**VILLAGE REVIEW BOARD
AGENDA
BRUNSWICK TOWN HALL
COUNCIL CHAMBERS
TUESDAY, MARCH 19, 2019
7:15 P.M.**

DRAFT FINDINGS OF FACT REQUEST FOR CERTIFICATE OF APPROPRIATENESS FOR STRUCTURAL ALTERATIONS VILLAGE REVIEW BOARD

PROJECT NAME: Second-Story Addition (Enclosed Office Space)

LOCATION: 26 Cumberland Street (Map U14, Lot 63)

Revisions			
Scale	1/4"=1'-0"	Drawn By	PHC
Date	1-17-19	Job No.	
		Project No.	
321 River Road Orrington, ME 04474 p: 207-745-7748 f: 207-825-4861 dfoxcampbellinc@yahoo.com			
Client/Project	THE McELLAN - CORP OFFICE		
Location	BRUNSWICK, ME		
	PLAN & ELEVATIONS		
Sheet No.	1 of 1

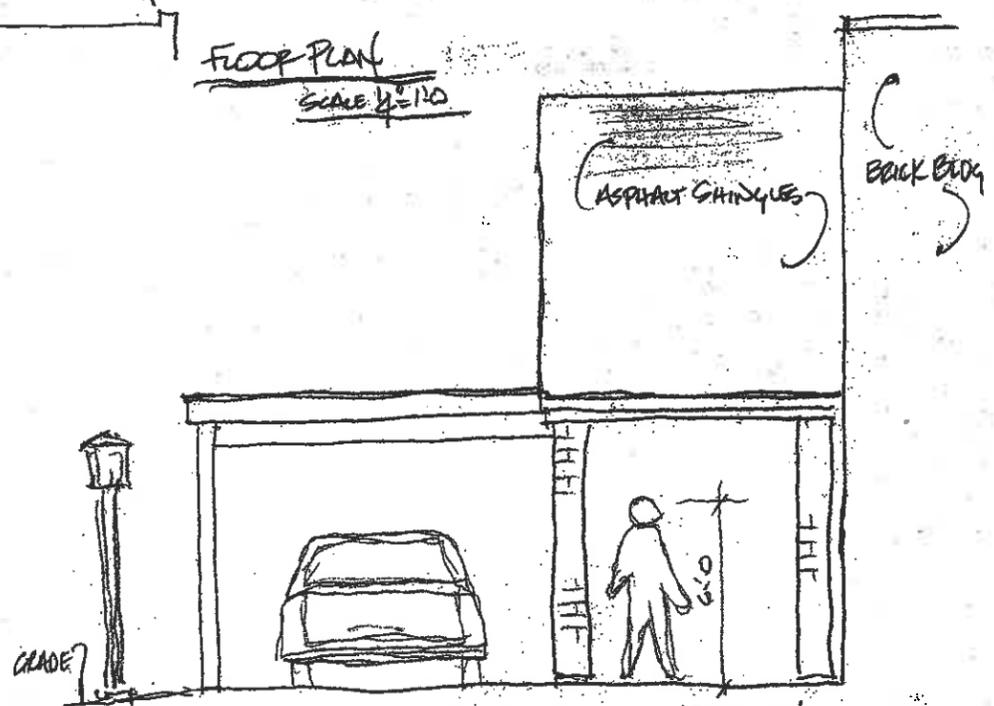
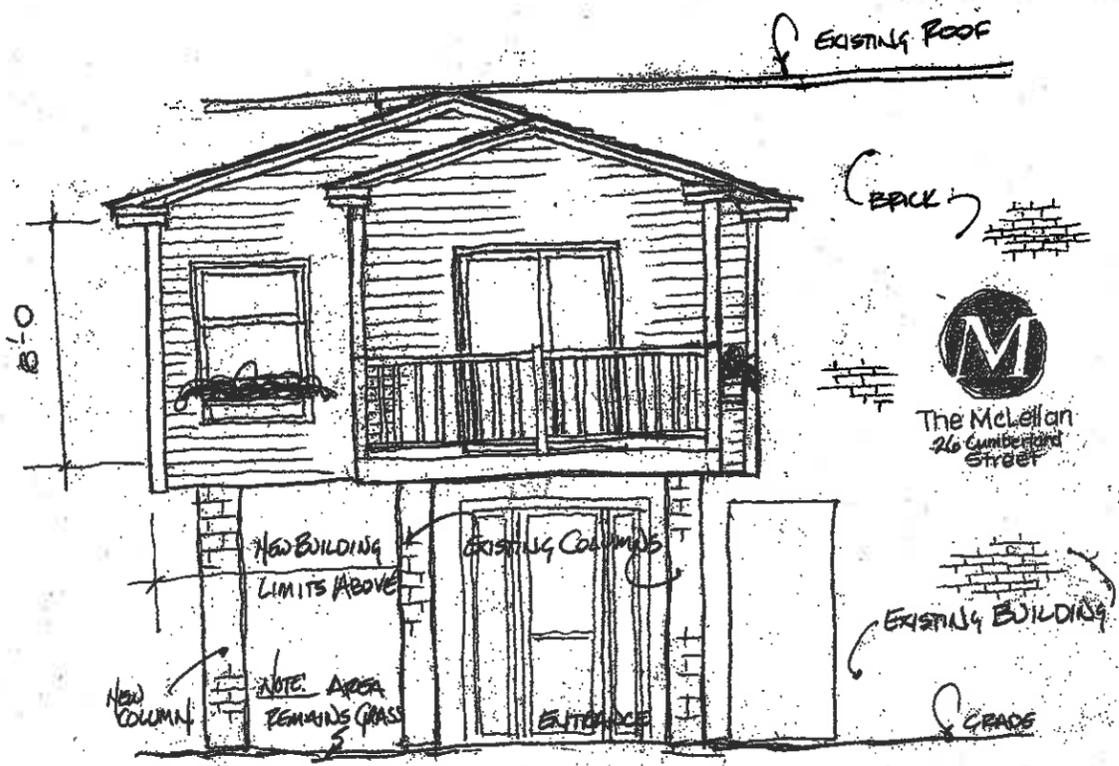
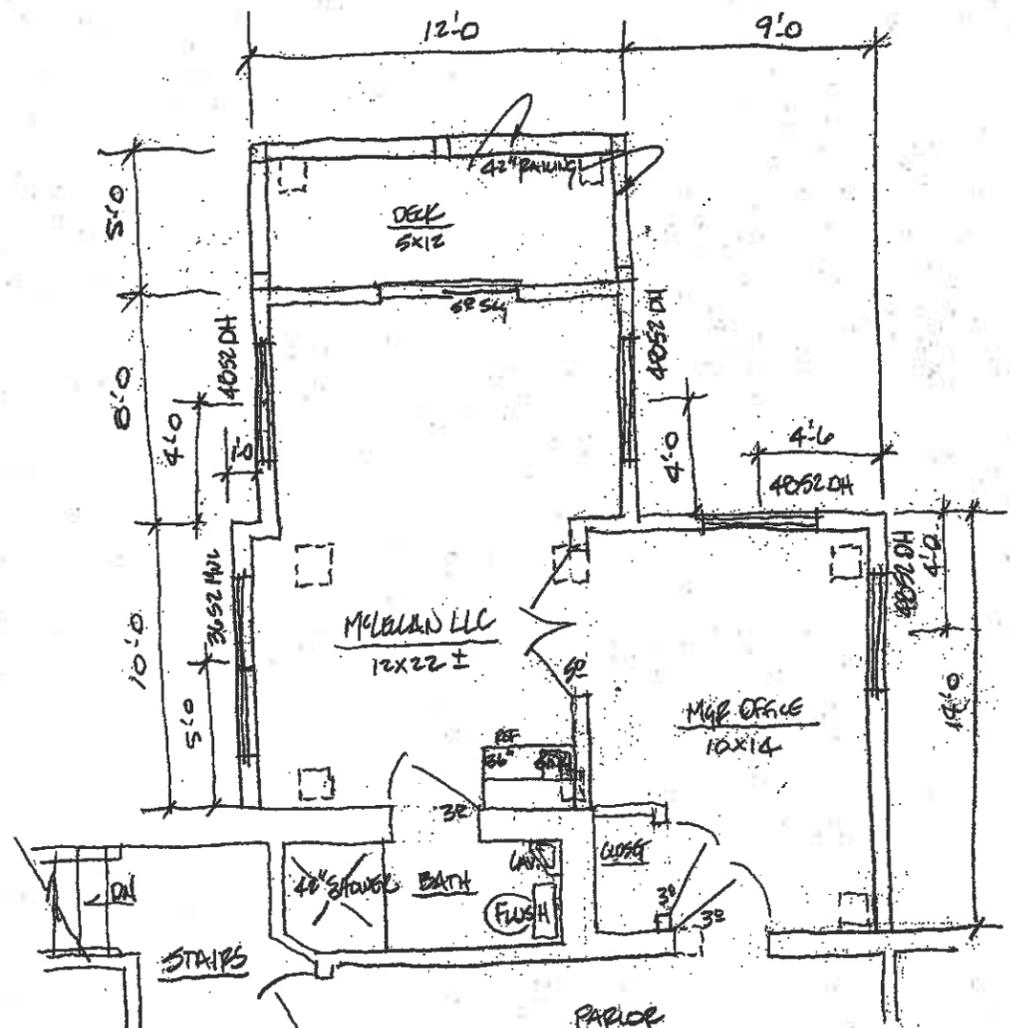
Much of the proposed addition will be built on top of the existing portico and the remaining new space will not be visible from the public right-of-way. As designed, the addition will be constructed with similar materials to the garage and within the surrounding contributing resources.

The proposed addition will retain the existing columns and the addition and its proposed location means that there will be minimal alterations to the existing structure.

The applicant has indicated that wood clapboard siding will be used for the addition. The applicant will provide a sample of the siding at the meeting. Failing the applicant providing a sample, a condition should be included specifying the use of wood clapboard siding.

1. That the Board's review and approval does hereby refer to these findings of fact, the plans and materials submitted by the applicant and the written and oral comments of the applicant, his representatives, reviewing officials, and members of the public as reflected in the public record. Any changes to the approved plan not called for in these conditions of approval or otherwise approved by the Director of Planning and Development as a minor modification, shall require further review and approval in accordance with the Brunswick Zoning Ordinance; and
2. That the applicant confirms the siding for the proposed addition will be wood clapboard.
